Intel[®] Pentium[®] III Processor Specification Update

Release Date: October 2002

Document Number: 244453-045

The Pentium[®] III processor may contain design defects or errors known as errata which may cause the product to deviate from published specifications. Current characterized errata are documented in this Specification Update.

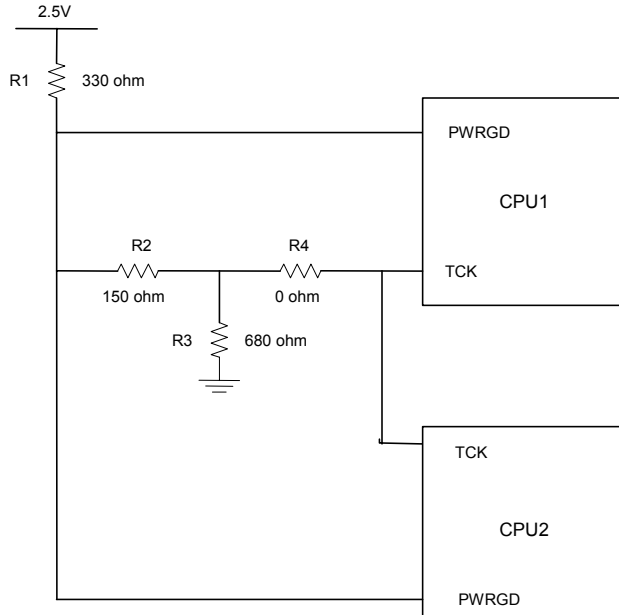
Problem: The internal control register bit responsible for operation of the Thermtrip circuit functionality may power up in a non-initialized state. As a result, THERMTRIP# may be incorrectly asserted during de-assertion of RESET# at nominal operating temperatures. When THERMTRIP# is asserted as a result of this erratum, the processor may shut down internally and stop execution but in few cases continue to execute.

Implication: This issue can lead to intermittent system power-on boot failures. The occurrence and repeatability of failures is system dependent, however all systems and processors are susceptible to failure. In addition, the processor may fail to stop execution during the event of a valid THERMTRIP# assertion resulting in the potential for permanent processor damage.

Workaround: To prevent the risk of power-on boot failures or catastrophic thermal failures, a platform workaround is required. The system must provide a rising edge on the TCK signal during the power-on sequence that meets all of the following requirements:

- Rising edge occurs after Vcc_core is valid and stable
- Rising edge occurs before or at the de-assertion of RESET#
- Rising edge occurs after all Vref input signals are at valid voltage levels
- TCK input meets the Vih min and max spec as mentioned in EMTS
